PLAN OF PROPOSED IMPROVEMENT

145 W. WILSON STREET

CITY PROJECT NO. 13759
CONTRACT NO. 9062

ADDENDUM & REVISION HISTORY

Utility Plan
Wilson 100
179 W. Wilson Street
Madison, Dane County, Wisconsin

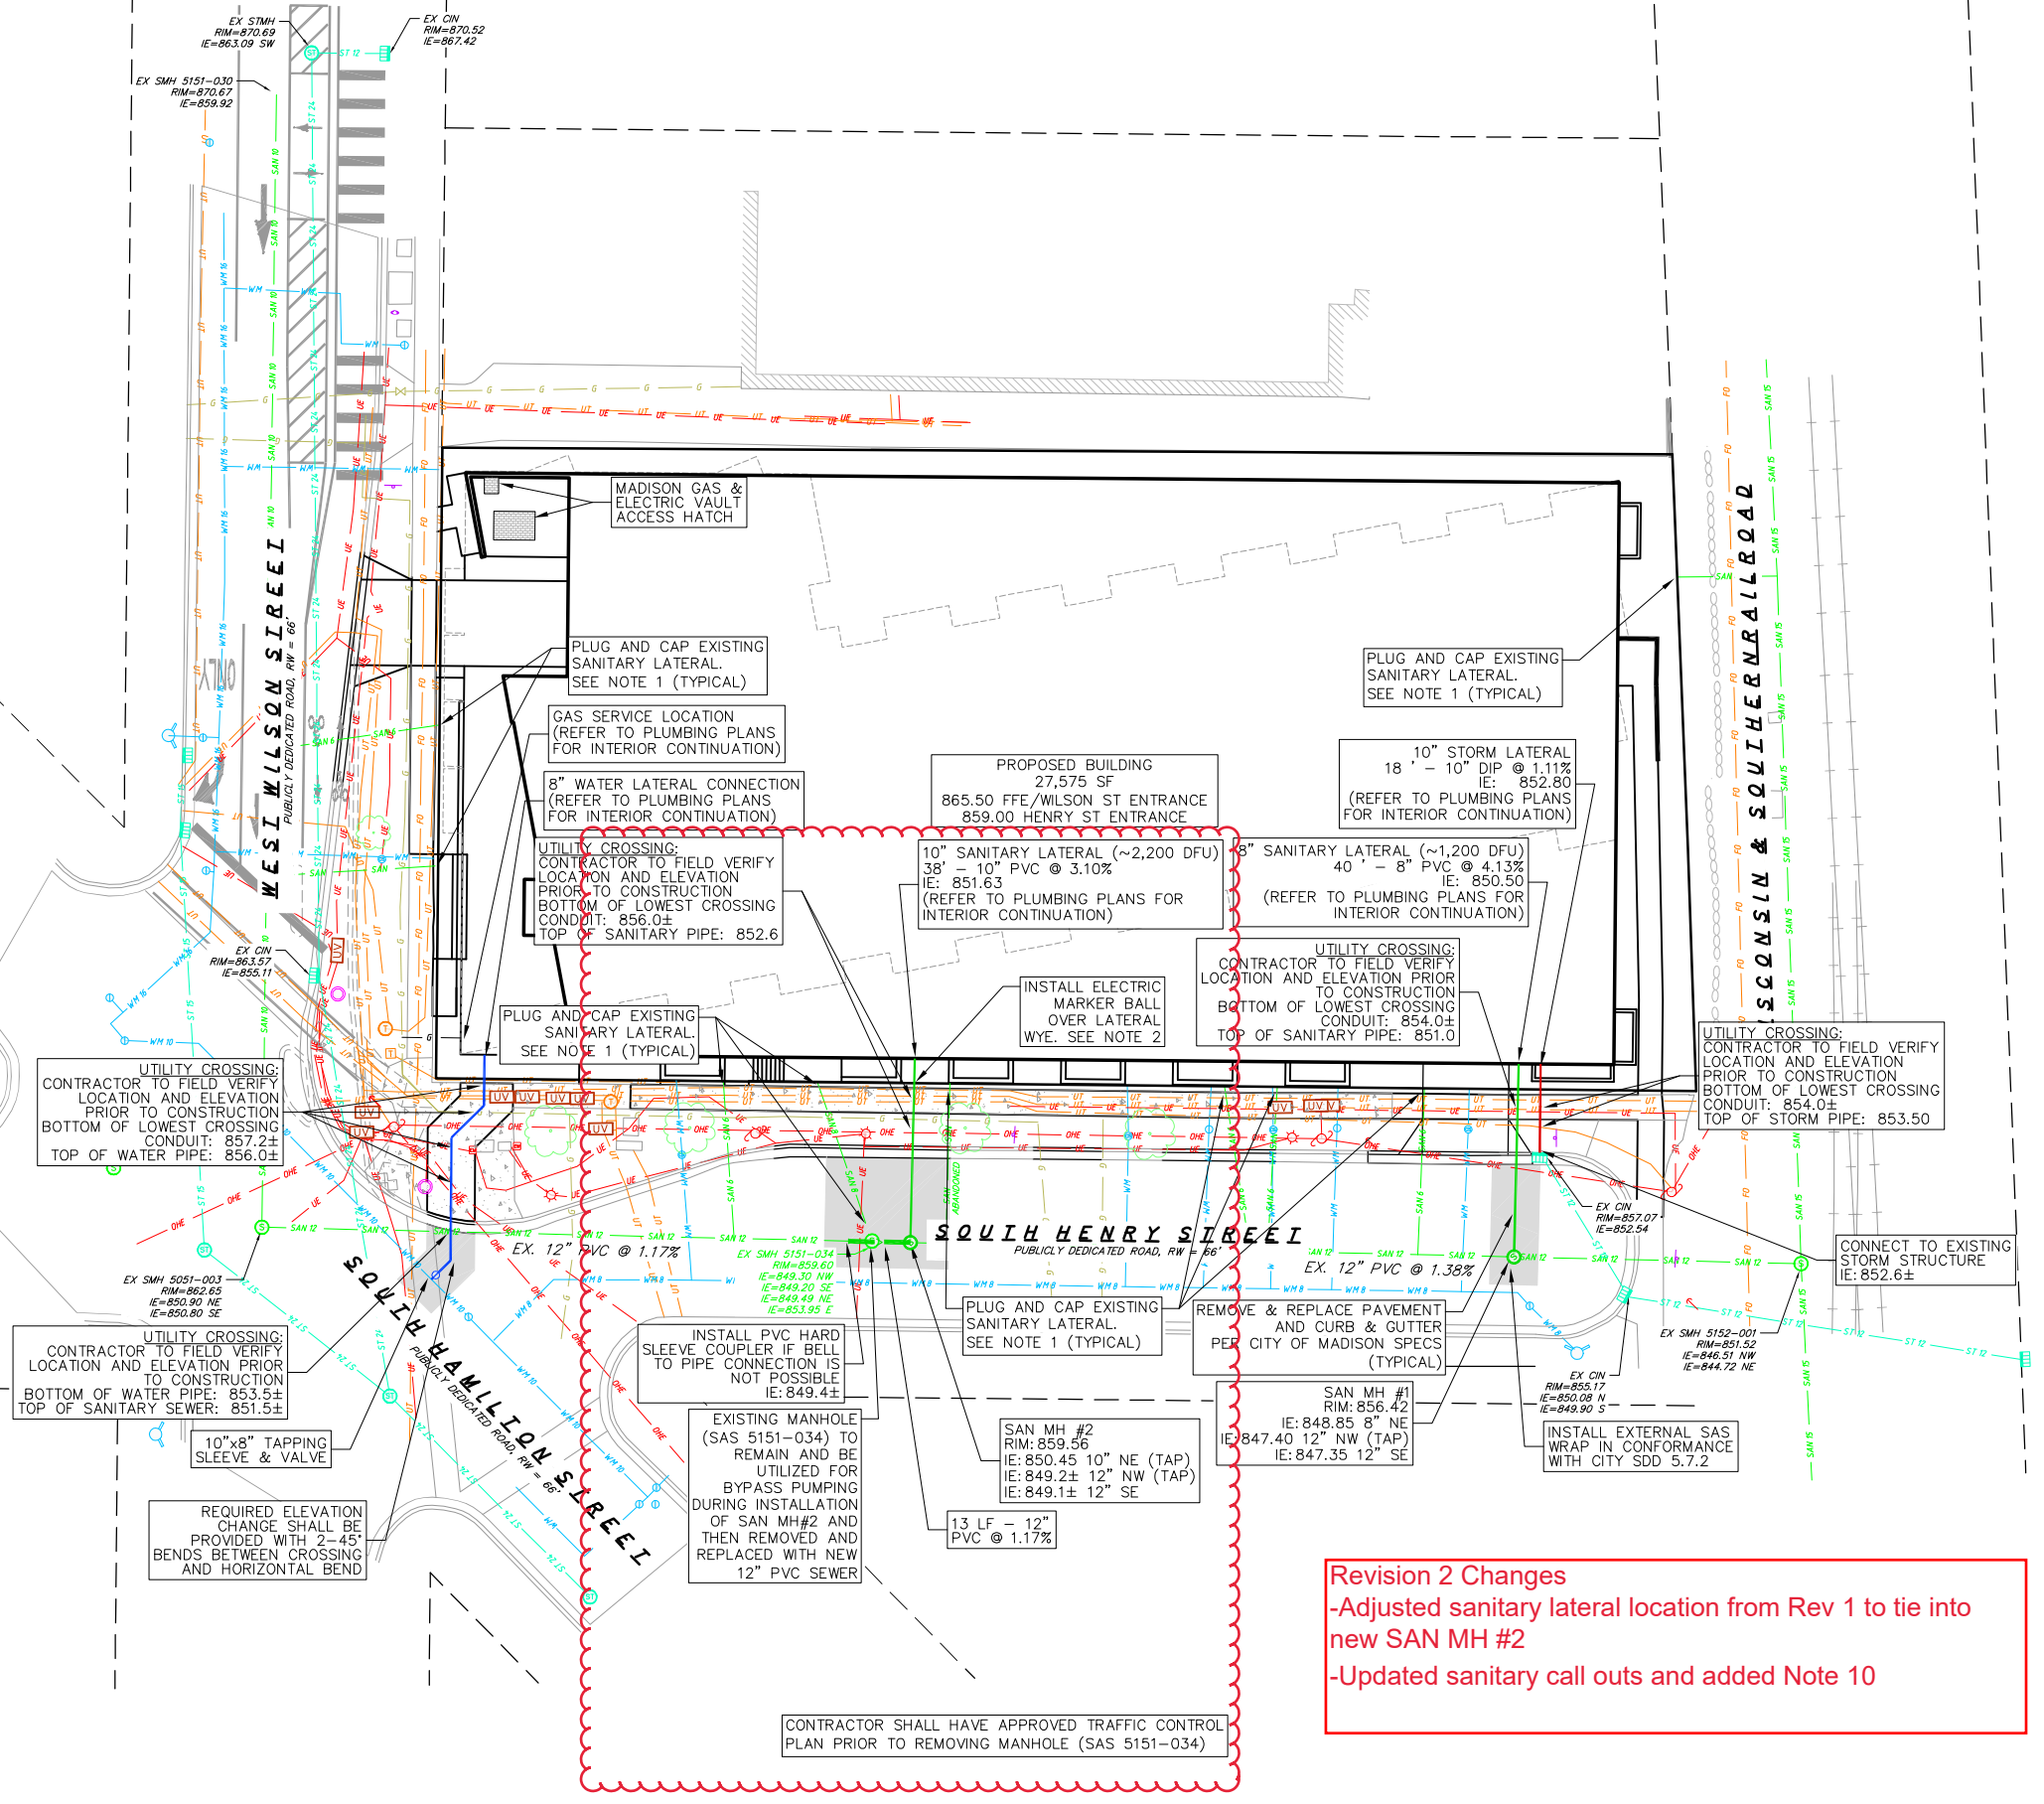
Revision 2 Changes
 -Adjusted sanitary lateral location from Rev 1 to tie into new SAN MH #2
 -Updated sanitary call outs and added Note 10
